# THE NATIONAL ACADEMIES

# Critique of the Sargent & Lundy Assessment of Cost and Performance Forecasts for Concentrating Solar Power

This letter report is the result of a brief but intensive study by the National Research Council (NRC) Committee for the Review of a Technology Assessment of Solar Power Energy Systems. Prepared for the U.S. Department of Energy's (DOE) Office of Energy Efficiency and Renewable Energy (EE&RE), this report critiques an assessment by Sargent & Lundy LLC (S&L), also contracted by the DOE, of the cost and performance forecasts for parabolic trough and power tower concentrating solar power (CSP) technology.<sup>1</sup> The NRC committee reviewed several drafts of the S&L document; however, this letter report is based mainly on Draft 3, which was delivered to the committee on October 12, 2002 [1]. The Executive Summary of that draft (SL-5641) is reproduced in Appendix A. Several post-October 12 revisions sent to the committee are also included in this analysis.<sup>2</sup>

**Figure ES-1 -Levelized Energy Cost Summary**

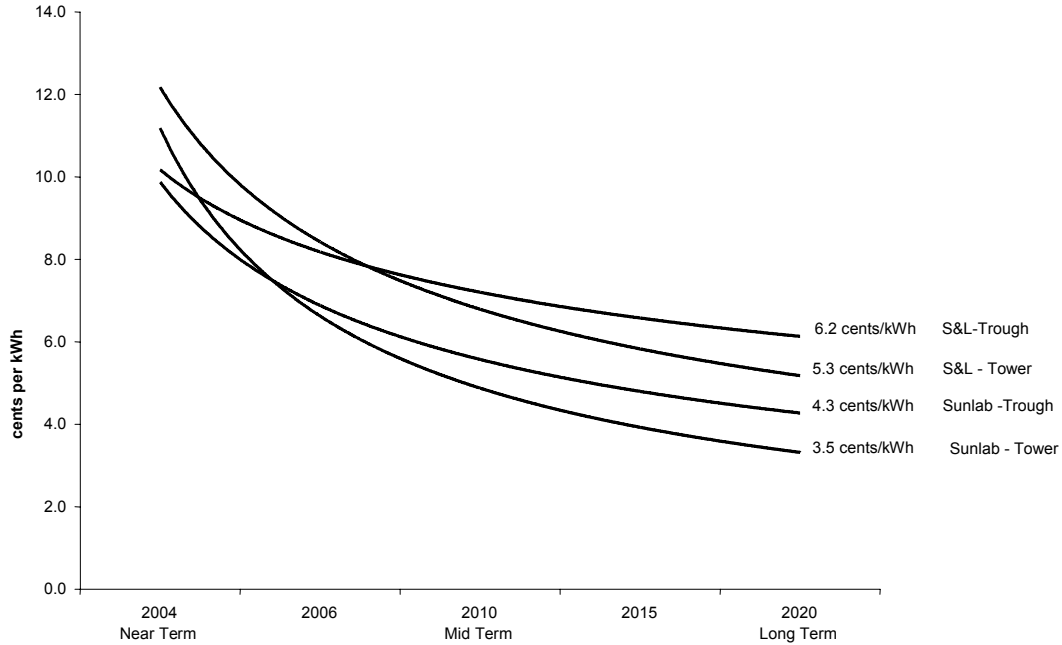
The S&L projection in Figure ES-1 in its report [1] shows CSP technology deployed with 100 MW each of trough and tower CSP capacity as being operational in 2004. Its report carefully notes, at the outset, the key assumptions for S&L’s assessment:

The committee believes that the S&L projection of a 100-MW plant being operational in calendar year 2004 is not credible on the basis of the information given in S&L's report [1]. Absent a statement that S&L has credible proprietary knowledge to the contrary, S&L's initial deployment projections should start later in time and the curve should shift to the right, further out in time. S&L's report and projection are deficient in this regard.
